# IGNITION SYSTEM

### OUTLINE OF CHANGE

Due to the changes on the spark plug of the 6G74-GDI engine and to the addition of the vehicles for Singapore, the following service procedures have been established.

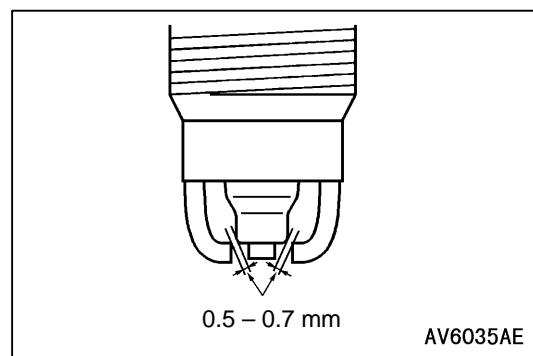
Item	Specification
Type	BKR5ETUR (NGK)

Item	Standard value
Spark plug gap mm	0.5 – 0.7
